MEMORANDUM

SUBJECT: Mandatory Referral No. 08403-USM-1: The Universities at Shady Grove Parking Garage – University System of Maryland, 9630 Gudelsky Drive, Rockville, LSC Zone, Potomac Subregion Master Plan (Shady Grove Study Area Plan)

STAFF RECOMMENDATION: APPROVAL with the following comments:

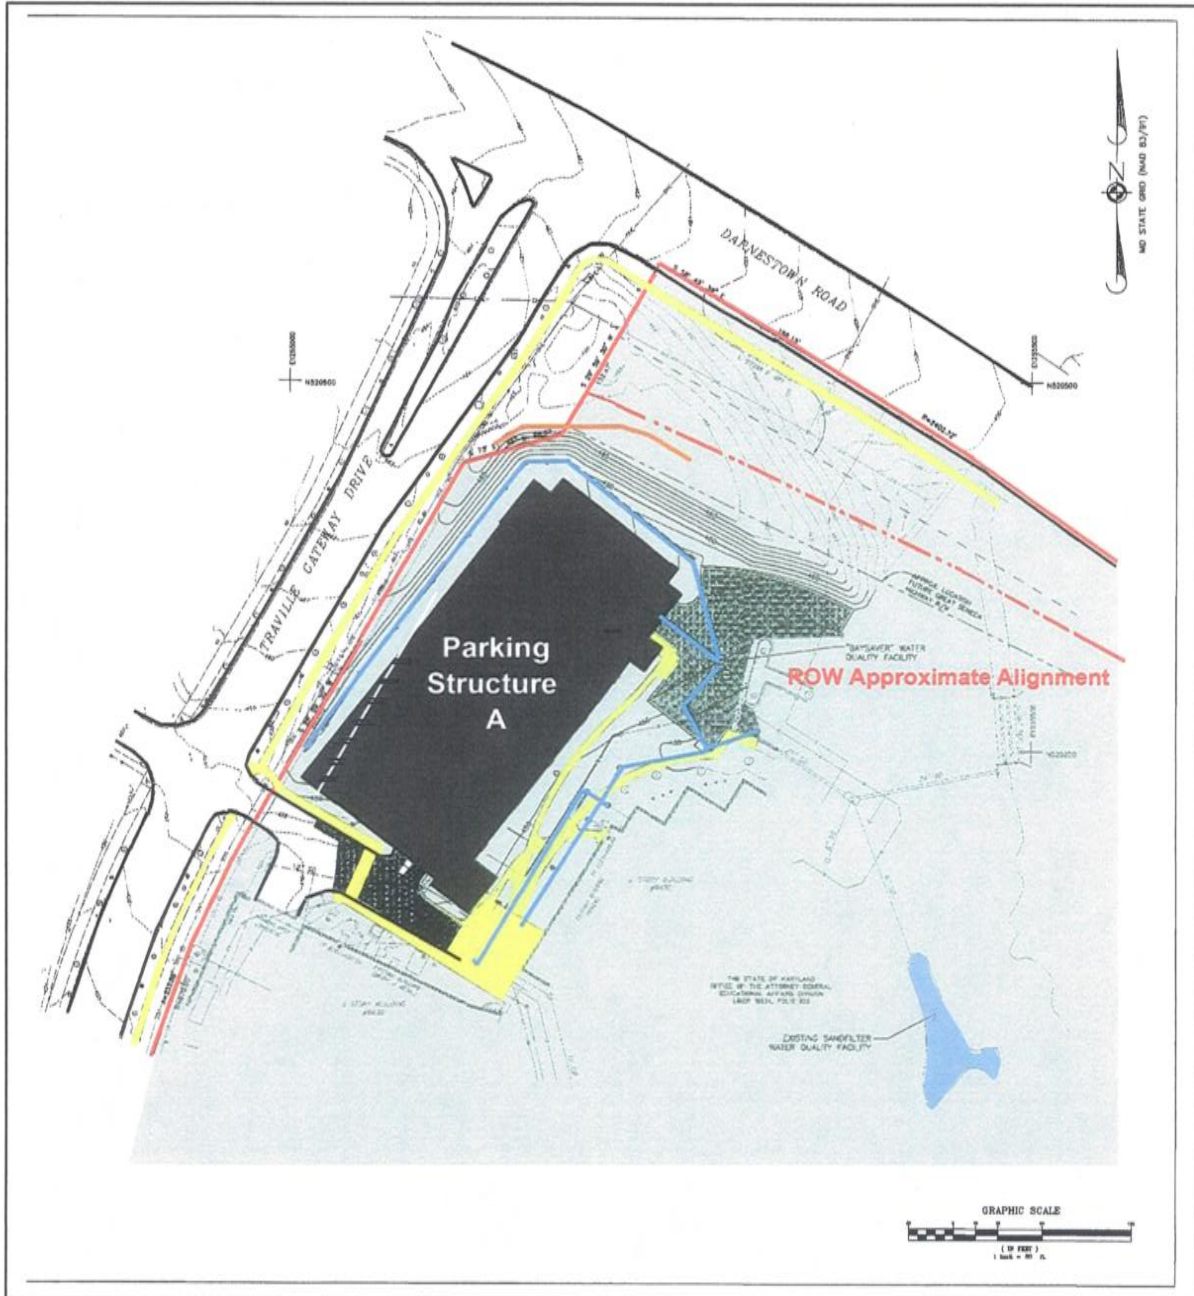
The building pushes toward the street, producing a reduced setback from Traville Gateway Drive that measures 14’-7” at its south corner. The setback increases along the building façade, vis-a-vis the slight rotation of the footprint, to realize the standard 25’ for accessory roads, at a point about 70 feet from its forward corner. The applicant states that the proposed disposition is necessary because of the required design capacity, physical relationship to the surrounding buildings, and to accommodate the future Darnestown Road right-of-way on the north. Staff finds that site design incorporating the setback reduction is adequate, safe, and efficient with respect to pedestrian and vehicular safety, sight distance, and reduction of pedestrian and

vehicular conflicts. The proposed plan is compatible with existing and future development: the subject building is set back from the curb line by at least 40 feet; the building footprint in question comprises a very small piece of the floor plate; the proposed structure will face an open lot used for surface parking; and, the lot confronts property which supports multi-family housing, zoned MXN which does not employ setbacks.
